CONTRACT CHANGE ORDER NO. ____
SHEET ___ OF ___

SAN FRANCISCO OAKLAND BAY BRIDGE
EAST SPAN SEISMIC SAFETY PROJECT
SELF-ANCHORED SUSPENSION BRIDGE
(SUPERSTRUCTURE & TOWER)

FLOORBEAM AT EAST TRANSITION NO. 5

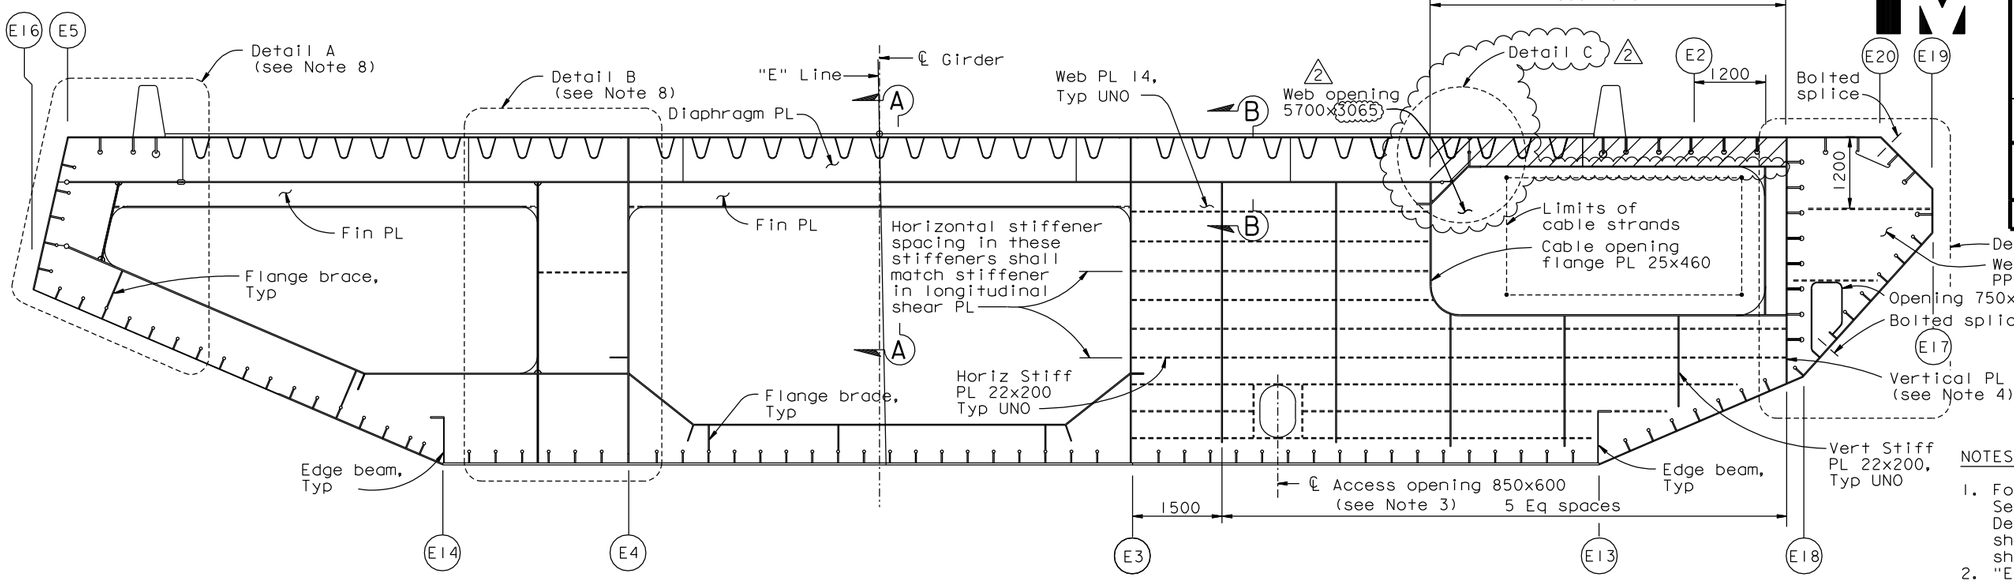
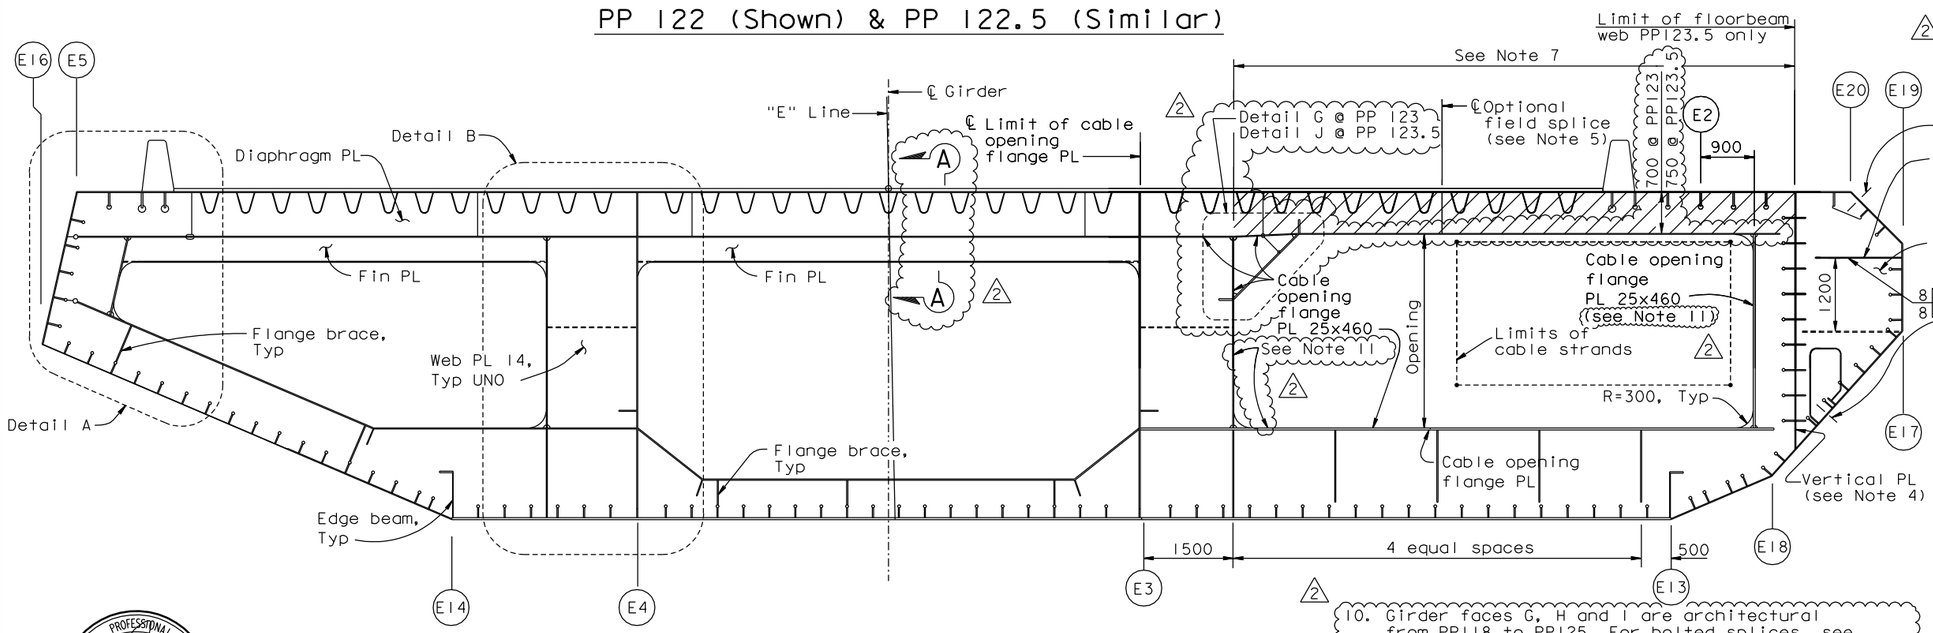
MARK	DATE	DESCRIPTIONS	BY	CH'D	CCO#
2	09/01/11	EAST END OBG	GB	MN	87
1	11/05/10	PP119 ACCESS & PP125 PLATES	GB	DT	86
